Drain: SAIL PLACE DRAIN **Drain #:** 298
Improvement/Arm: SAIL PLACE - FALL CREEK HARBOUR - SECTION 1
Operator: SLM/JOH **Date:** 4-27-04
Drain Classification: Urban/Rural **Year Installed:** 1998

RE: Sail Place Drain, Fall Creek Harbour Arms

Re: Sail Place Drain: Fall Creek Harbour Arm

AS-BUILT CONSTRUCTION DRAWINGS FOR FALL CREEK HARBOUR

FALL CREEK HARBOUR STORM SEWER PLAN & PROFILE

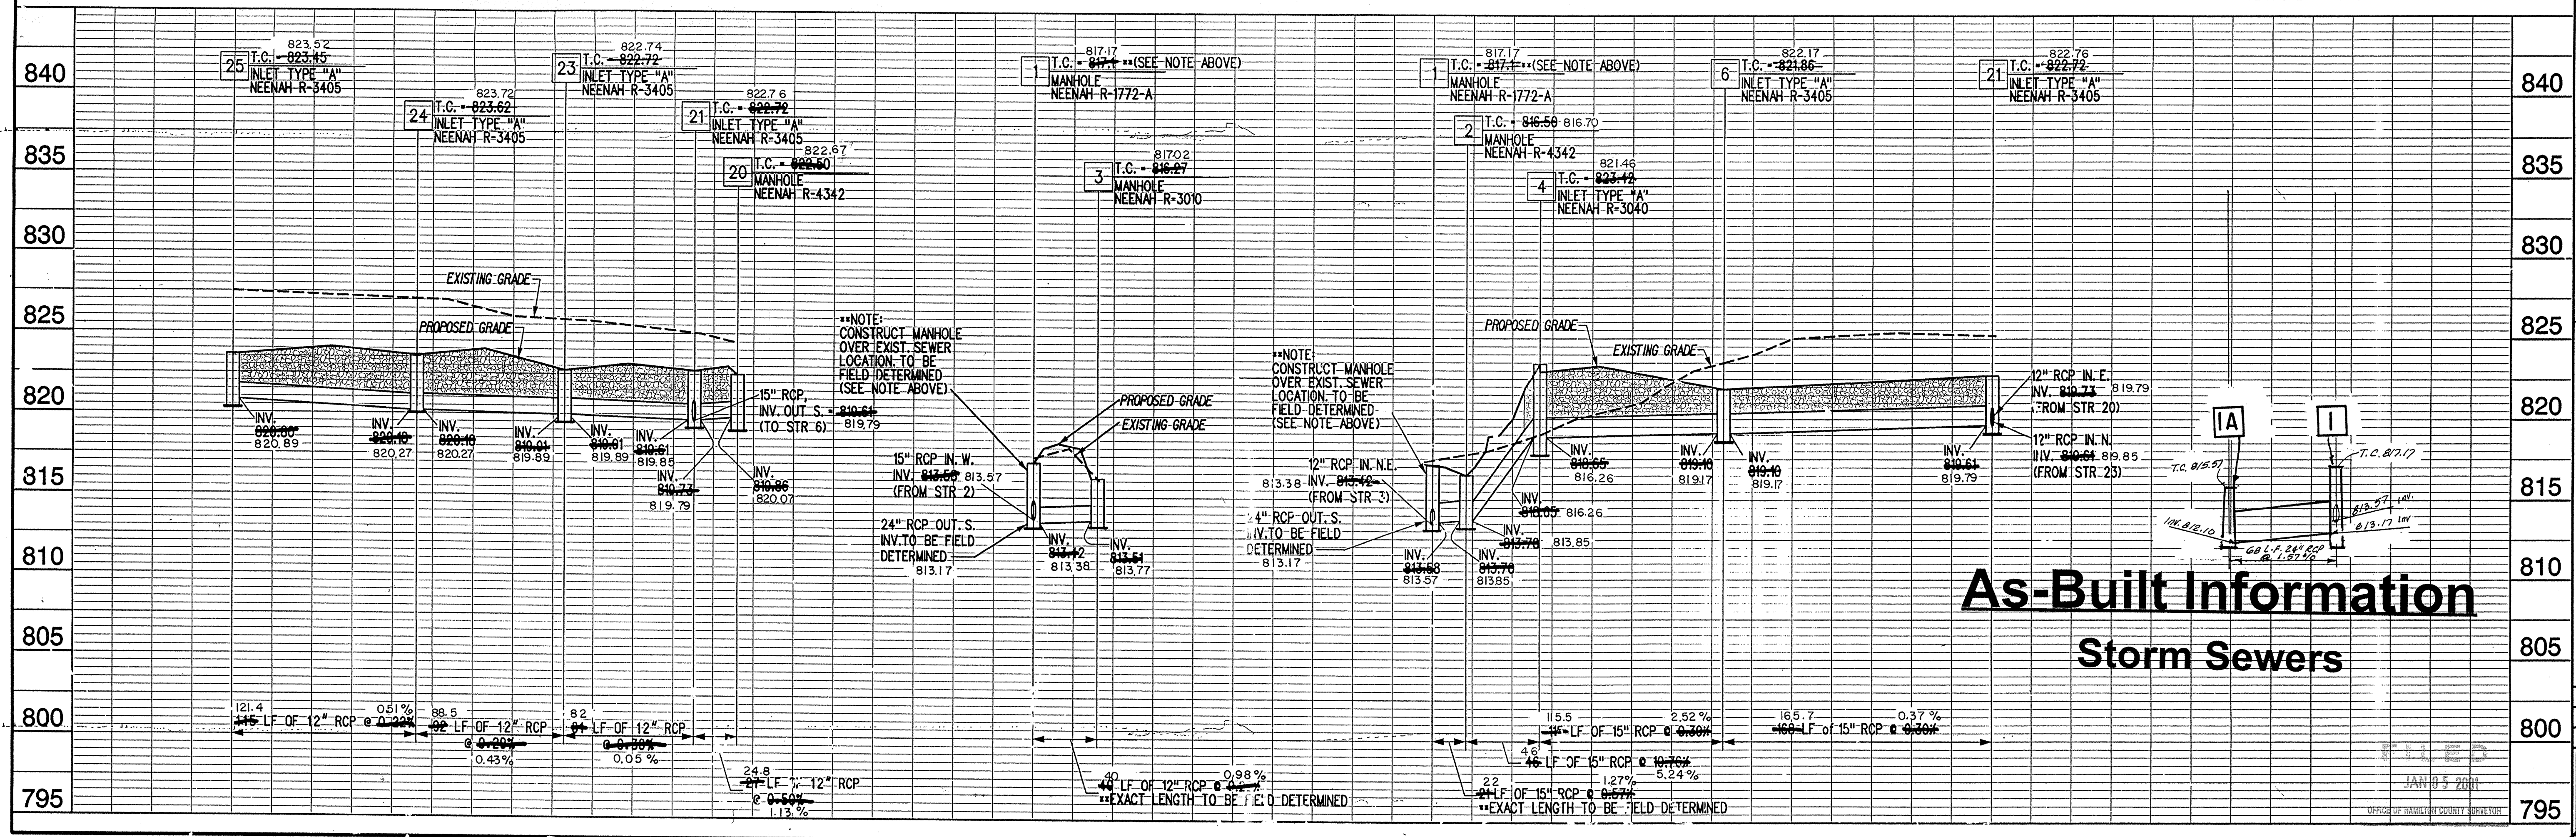
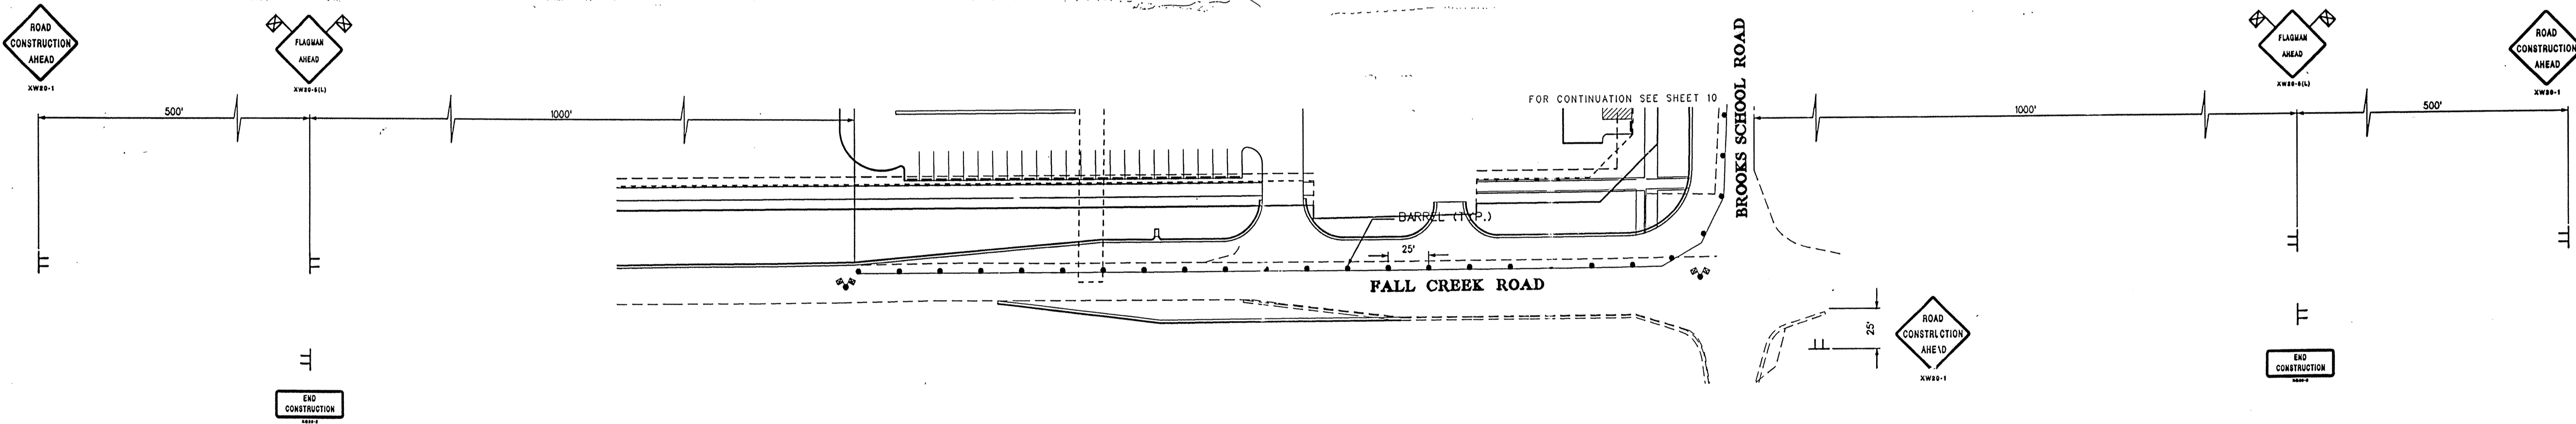
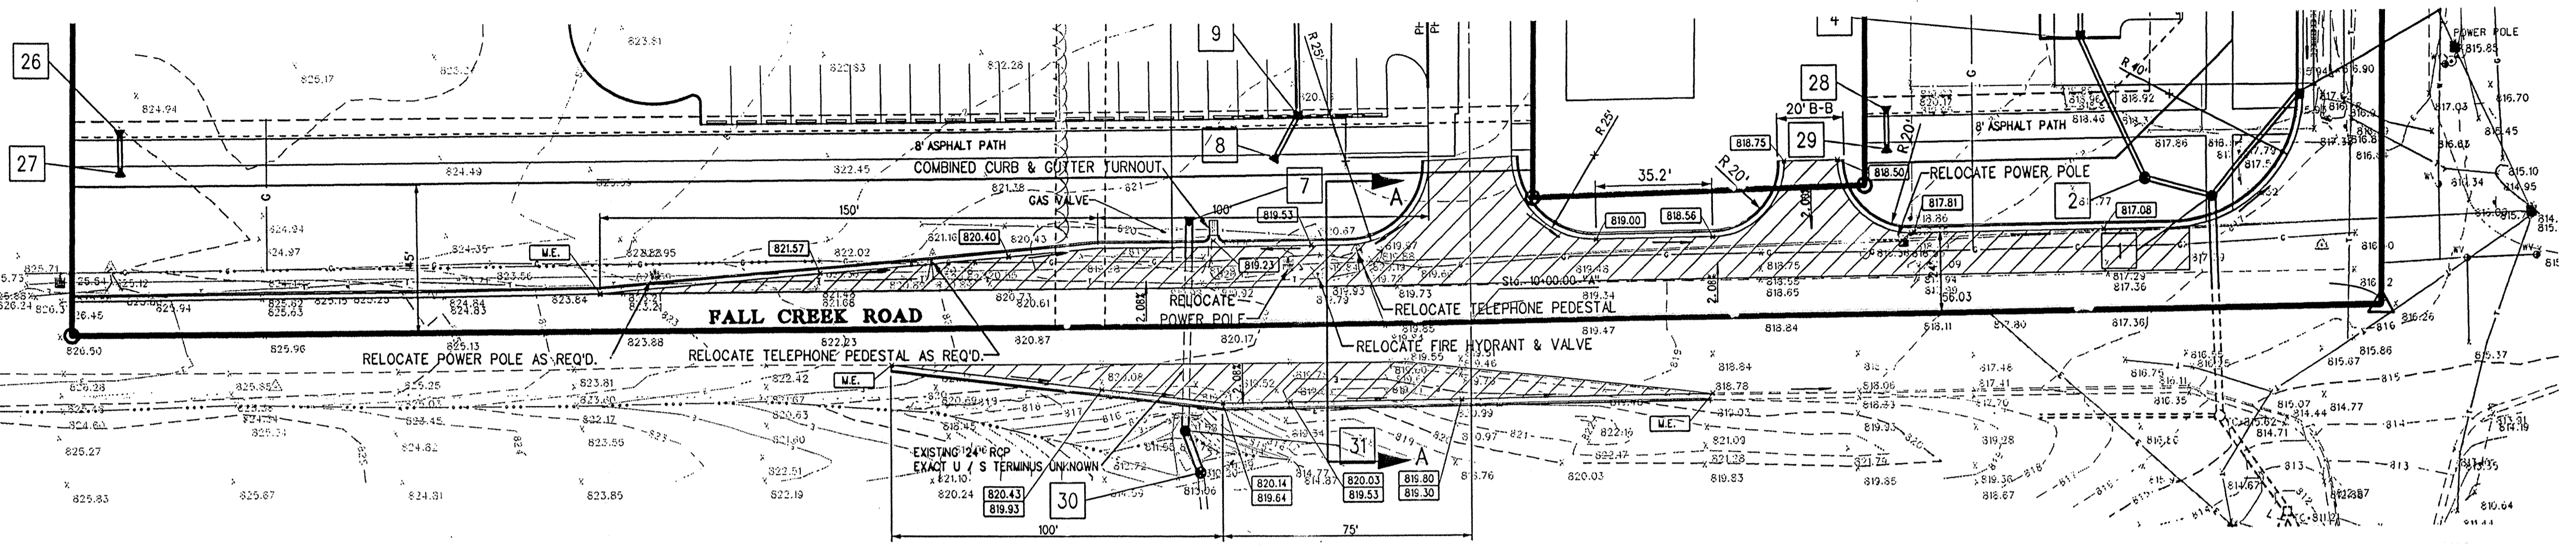
During construction, changes were made to the drain, which will alter the plans submitted with my report for this drain-dated August 7, 1998. The report was approved by the Board at the hearing held September 28, 1998. (See Drainage Board Minutes Book 4, Pages 589-590)

STR 1 - 2 length of 15" RCP was increased from 21 feet to 22 feet.

STR 1-711 length of 24" RCP was increased from 65 feet to 68 feet.

The length of the drain due to the changes described above is now **202 feet**.
